PRELIMINARY SITE GRADING CONSTRUCTION PLANS
FOR
THE HILLS AT LORSON RANCH
EARLY OVERLOT GRADING / EROSION CONTROL PLANS

PROJECT:
THE HILLS AT LORSON RANCH
FONTAINE BLVD. HALLEY DR
COLORADO SPRINGS, COLORADO

COVER SHEET
EARLY GRADING AND
EROSION CONTROL PLAN

PUDSP-20-00X

**TYPICAL SECTION 50' R.O.W.
RESIDENTIAL URBAN LOCAL**
NOT TO SCALE

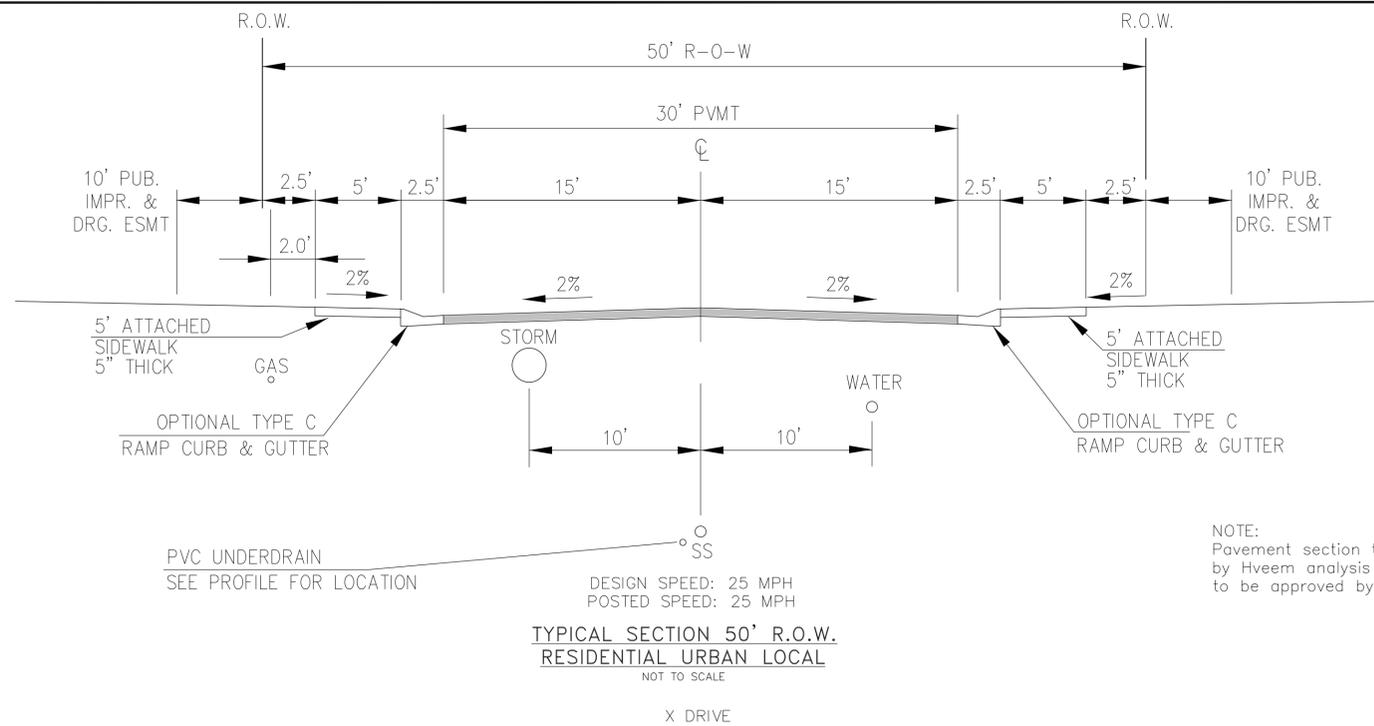
add date of report

SHEET NUMBER **C4.1**

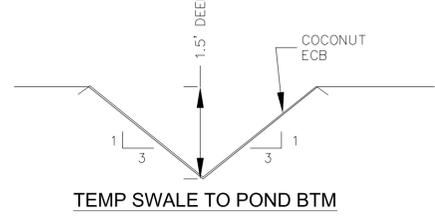
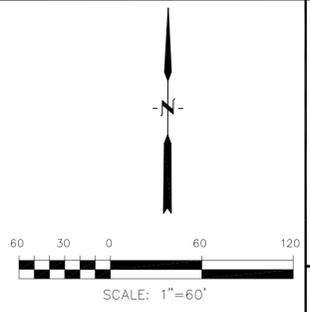
Show TS and permanent seeding on figures

If the same as the limits of disturbance, change to "construction boundary/limits of disturbance" or add "limits of disturbance" to the legend and figure

This VTC location is OK but will have to add barricade to prevent trucks from driving on Grayling Drive North when exiting the Site. Will also have to keep Lamprey Drive swept to prevent cross contamination with existing residents.

May want to move the VTC to a location onsite.
